STAFF REPORT  
DIXON, TAYLOR, LEVINGS  
SWEET LANE TOWNHOMES  
151 SWEET LANE  
SUBDIVISION S 2-22  
MAY 18, 2022

To: Eric Mongan, City Planner  
From: Damien Gilbert, P.E. Branch Engineering Inc, City Engineer  
Subject: ENGINEERING COMMENTS FOR S 2-22  
**Sweet Lane Preliminary Subdivision – Bob Dixon Investments LLC**  
Date: May 3, 2022

**PRELIMINARY PLAT  
SWEETLANE TOWNHOMES**

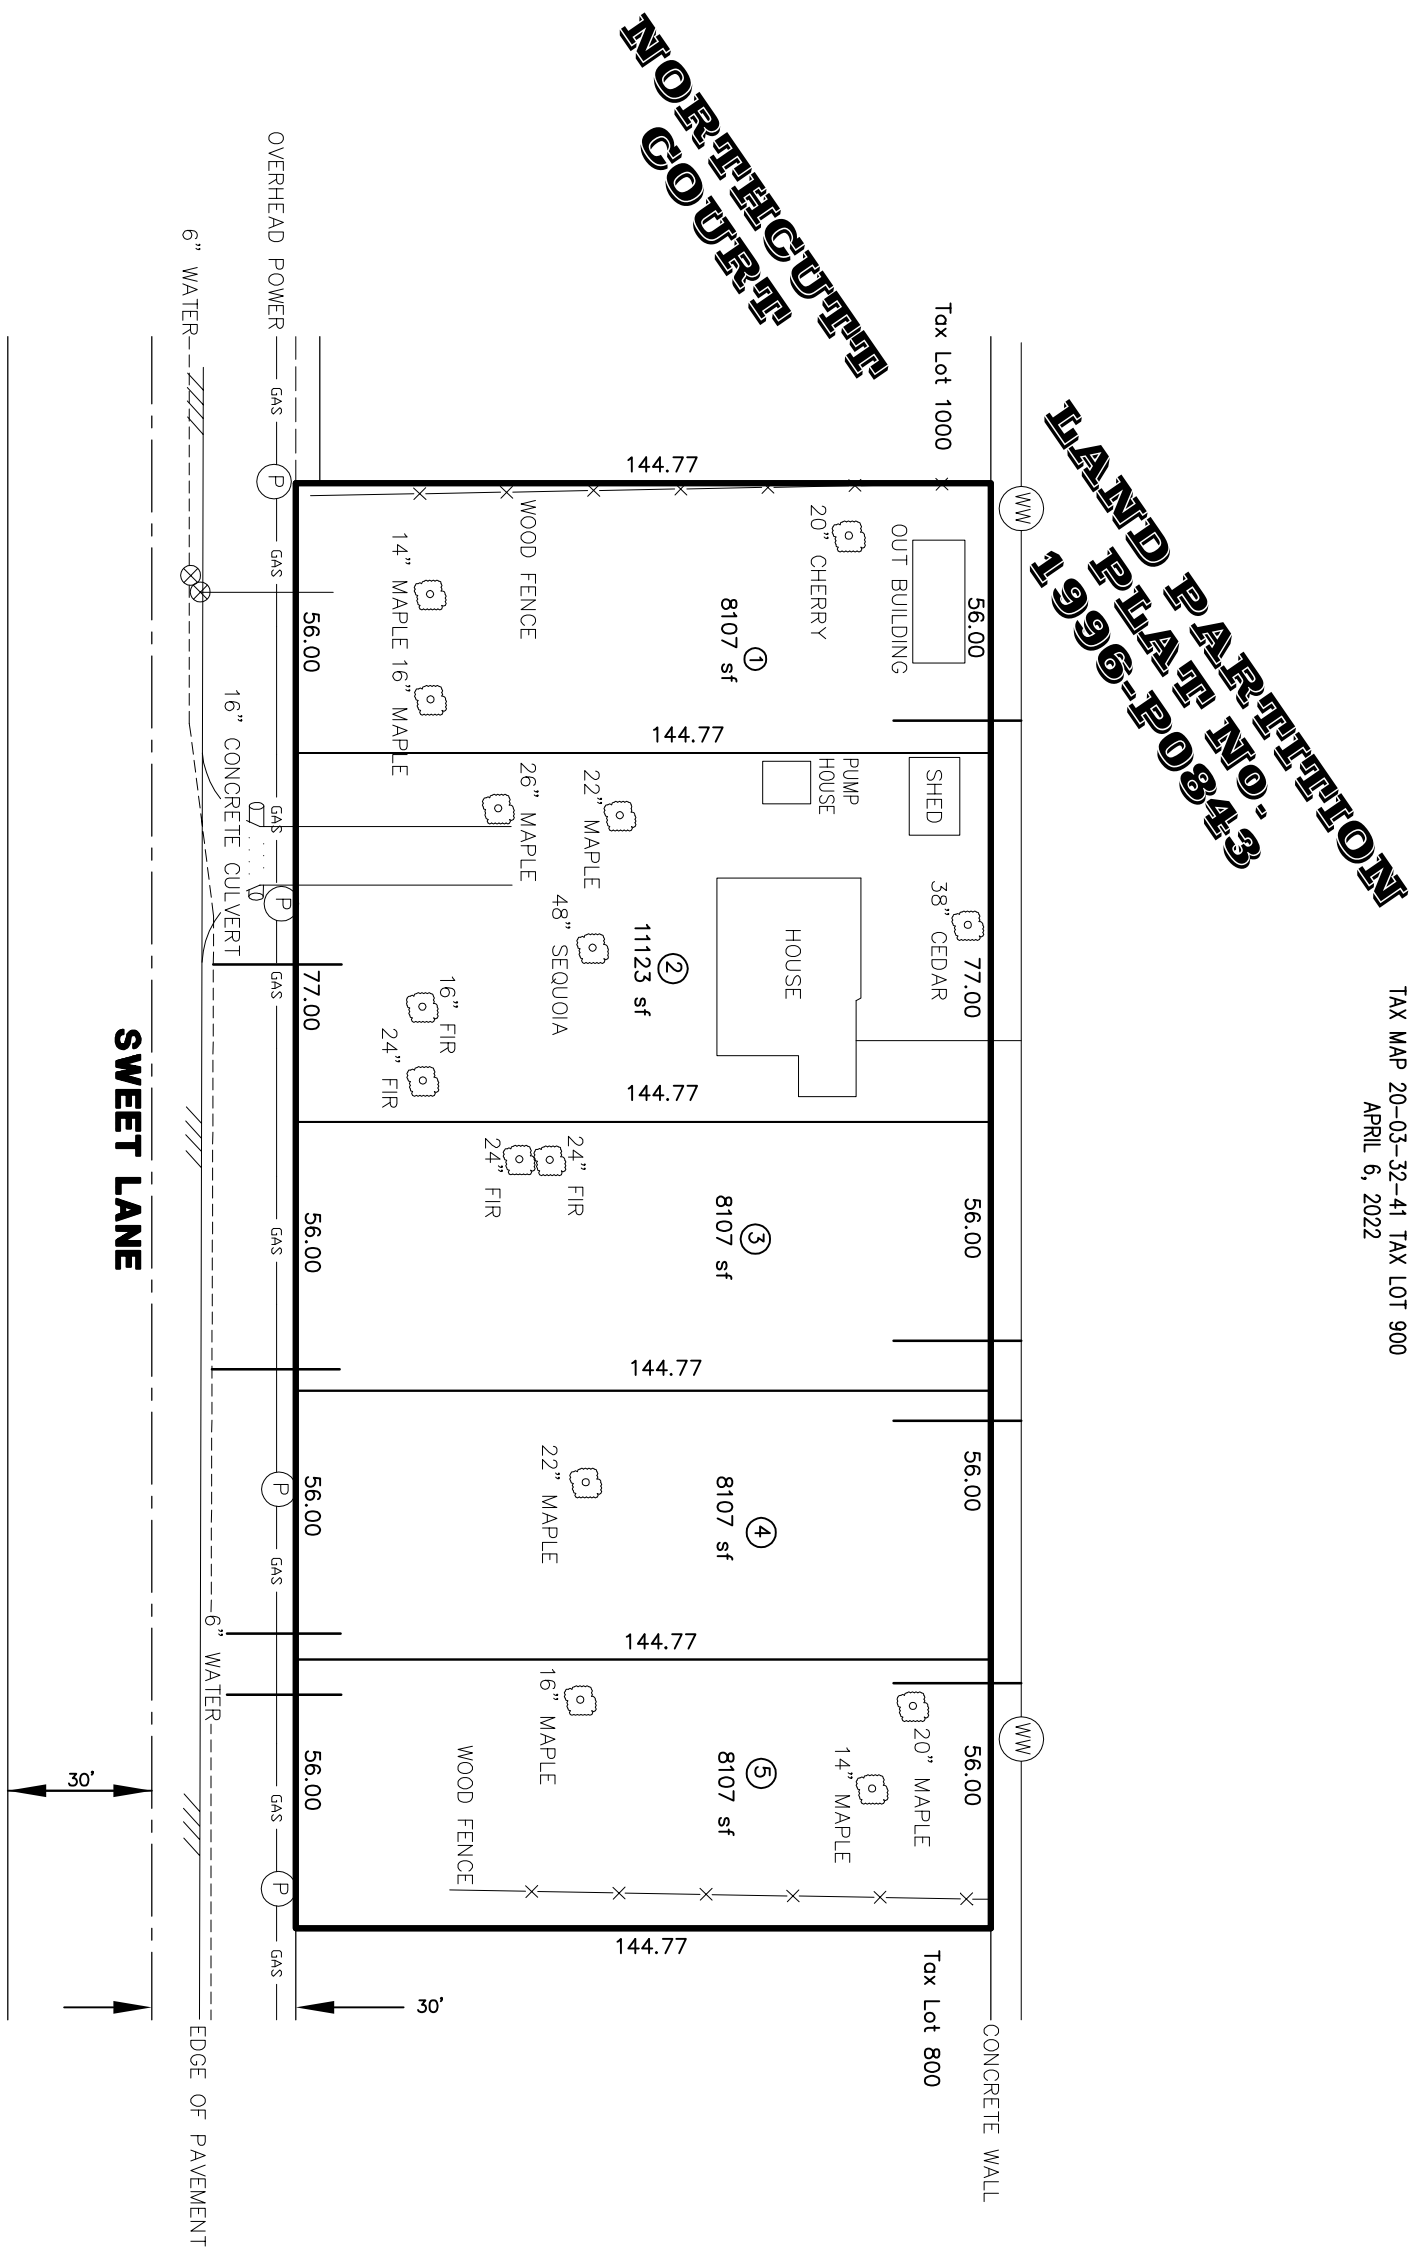
- Developer, Property Owner or Surveyor shall provide the City of Cottage Grove with a Mylar copy of the filed plat for the City's records.
- Proposed subdivision does not show any public utility easements along the frontage of the lots. The proposed subdivision doesn't show a right of way dedication or Public Utility Easement along the frontage. These should be shown if needed or as required prior to finalizing the plat. If it is not included, a special setback should be required if needed.

- There are no provisions for management of future stormwater runoff. This will need to be addressed with the building permit.
- There are no improvements proposed to Sweet Lane, an unimproved street. Future widening, curb and gutter, sidewalks, and stormwater improvements are anticipated in the future. If those improvements are not proposed prior to recording of the plat, a non-remonstrance agreement should be in place.
